Hydrol. Earth Syst. Sci. Discuss., author comment AC1
<https://doi.org/10.5194/hess-2021-5-AC1>, 2021
© Author(s) 2021. This work is distributed under
the Creative Commons Attribution 4.0 License.

Reply on RC1

Author comment on "Drought-induced non-stationarity in the rainfall-runoff relationship invalidates the role of control catchment at the Red Hill paired-catchment experimental site" by Yunfan Zhang et al., Hydrol. Earth Syst. Sci. Discuss.,
<https://doi.org/10.5194/hess-2021-5-AC1>, 2021

Response to Reviewer #1

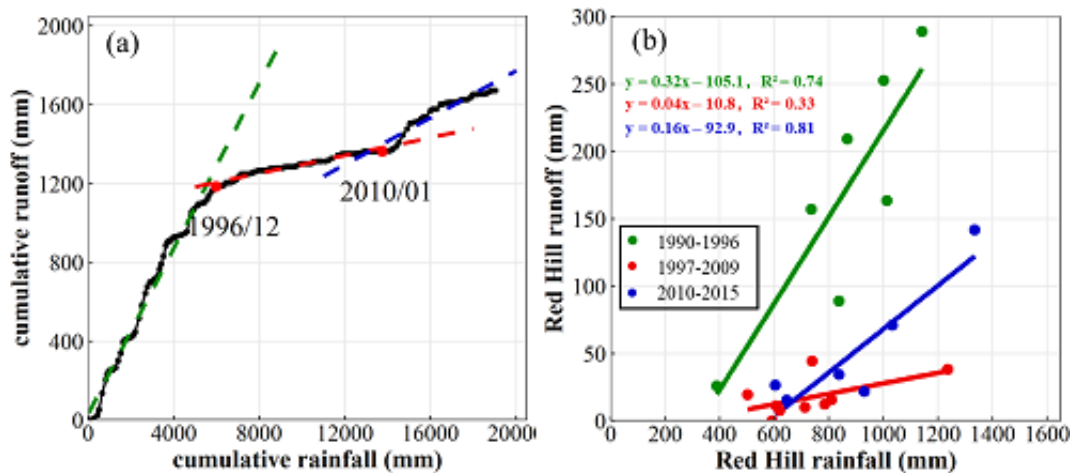
- It's a flaw that the manuscript lacked detection of changes in the rainfall-runoff relationship for the treated catchment. Although it's obvious why there is a control and a treated catchment, I think it's important to apply the appropriate parts of the applied analysis for the treated catchment, also to have a better understanding of the underlying processes; to confirm or to deny the non-linear behaviour of the treated catchment.

A. If the treated catchment has not been reforested, did you expect the treated catchment to show similar behaviour as the control catchment?

B. Does the treated catchment already shows the same non-linearity as the control catchment?

B. Yes, the treated catchment shows the similar non-linearity as the control catchment, as shown in Figure R1 and Figure 5 (Page 39). But observed changes in treated catchment should be driven by two factors, i.e. afforestation and prolonged drought by assuming prolonged drought can lead to changes in rainfall-runoff relationship of the treated catchment.

Figure R2 The variation in monthly rainfall of the Kileys Run catchment (control catchment), New South Wales, Australia, during the periods of 1990–2015.

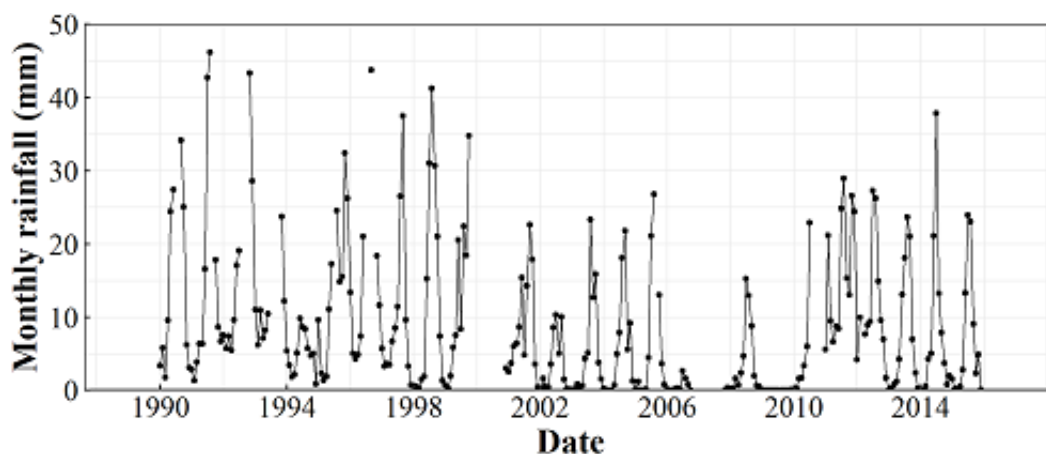
- Lines 139-147; what is the variation in monthly rainfall? Seasonal? What Köppen climate?

The variation in monthly rainfall can be seen in Figure R2. Seasonal changes in monthly rainfall can be seen in Figure R3. The monthly rainfall decreased great during the period of 2001-2009 and increased after 2010, but is still less than the monthly rainfall before 2001. There is more precipitation in winter (June, July and August), but the difference amongst rainfall of four seasons is small. The climate type in Kileys Run and Red Hill catchment is Cfb (temperate maritime climate) (Peel et al., 2007).

Figure R4. (a) Monthly runoff at control (Kileys Run) vs. treated (Red Hill) catchments in New South Wales, Australia, during the calibration period, and (b) Monthly rainfall vs. runoff of the treated catchment during the calibration period. Dashed line is the 1:1 line.

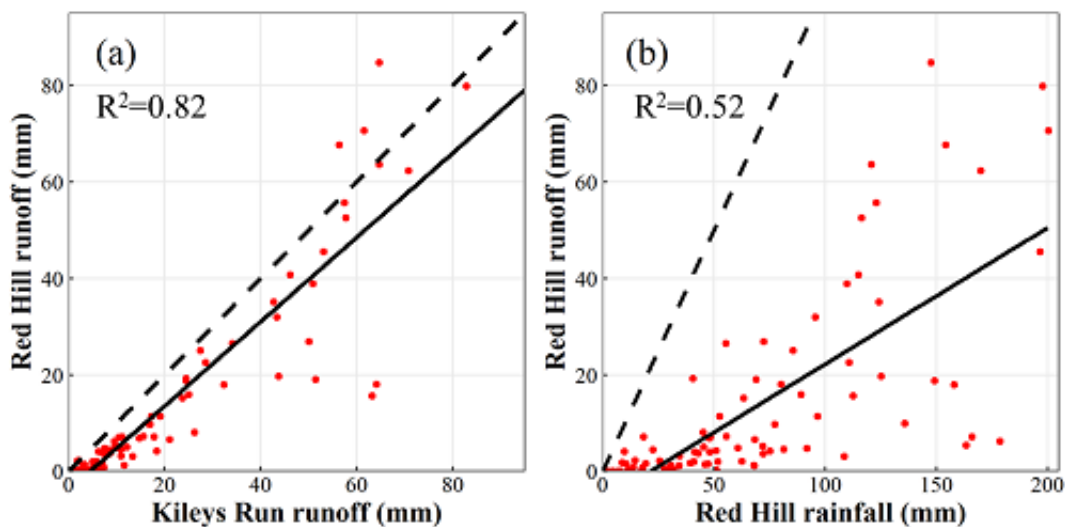
- Figure 4. A. The left figure is Kileys Run, but in the caption you mention Red Hill first, change either the caption or the figure order. B. The x- and y-axis do have different ranges, this makes the graphs difficult to compare and to understand the meaning of the results.

Reply: Thanks for your helpful suggestions. Figure 4 will be replaced by Figure R4 in revised manuscript as follows:

A. The title of Figure 4 has been changed to that of Figure R4.

B. The runoff-runoff relationship for the two paired catchments in Figure 4 (a) is used in the paired catchment method, and the rainfall-runoff relationship of the treated catchment in Figure 4 (b) is used in the time-trend analysis method.

Figure R5. Daily flow duration curves of the Kileys Run catchment (i.e., control catchment), New South Wales, Australia, over four different periods (see legend).

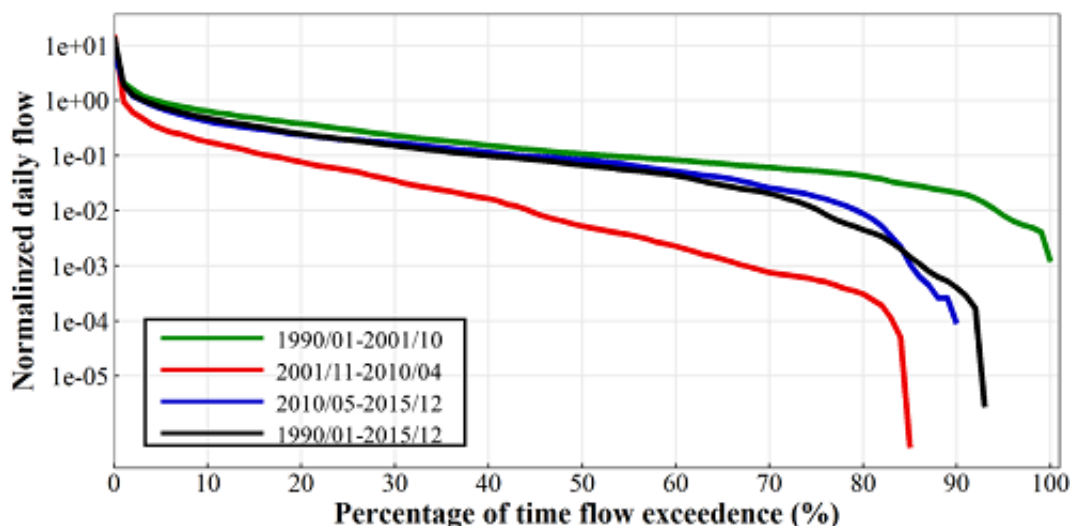
- Figure 6; you may consider add the daily flow duration curve for the entire measurement period (1990-2015) to indicate the differences;

Reply: Thanks for your helpful suggestions. The daily flow duration curve including the entire measurement period (1990-2015) can be seen in Figure R5.

The FDC of the entire measurement period (1990-2015) is close to the FDC of the third

period (2010-2015). There is 6% no-flow days during the whole period. In the first period (pre-drought), the second period (after drought) and the whole period (including the whole drought period), high flows have a highly consistent change, but the difference amongst low flows is significant. It indicates that the impact of prolonged drought on the low flow is more serious than that of the high flow. When the rainfall increases, the high flow may recover quickly, but the low flow may recover slowly.

Figure R6. Estimated monthly values of parameters (a) C and (b) SC used in the two-parameter monthly water balance model for the Kileys Run catchment (control catchment), New South Wales, Australia, during the period of 1990–2015.

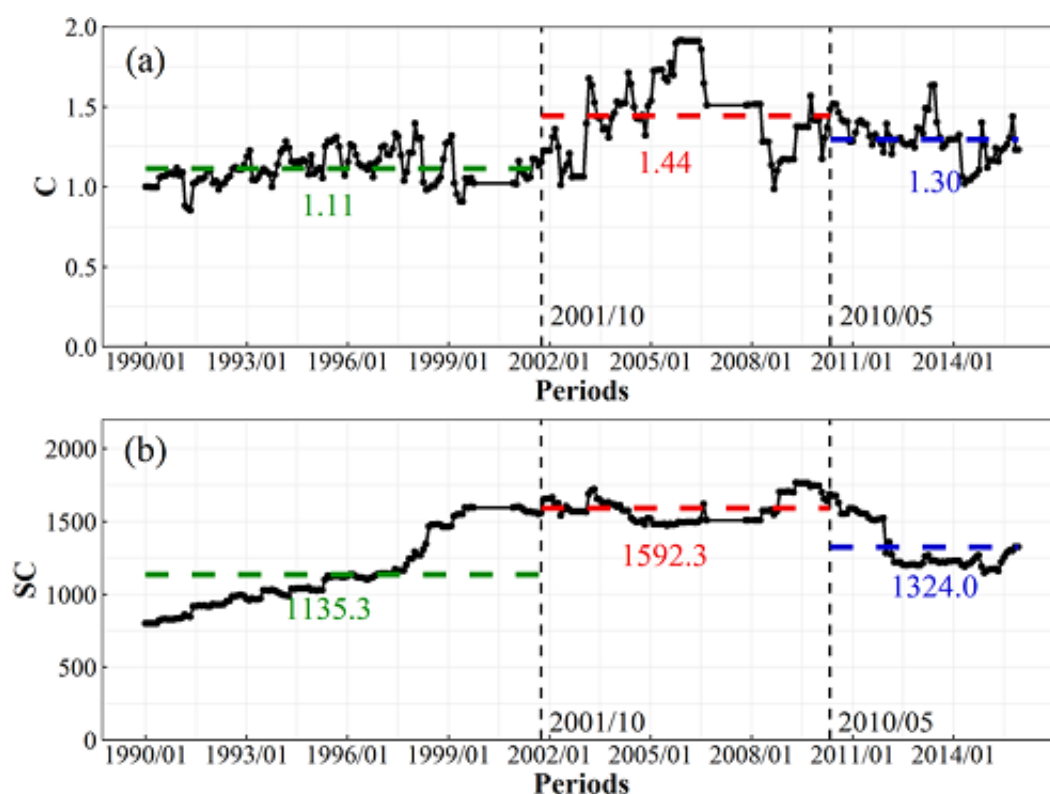
- Figure 7; The x-axis of the graphs could be better aligned;

Reply: Thanks for your helpful suggestions. Figure 7 will be replaced by Figure R6.
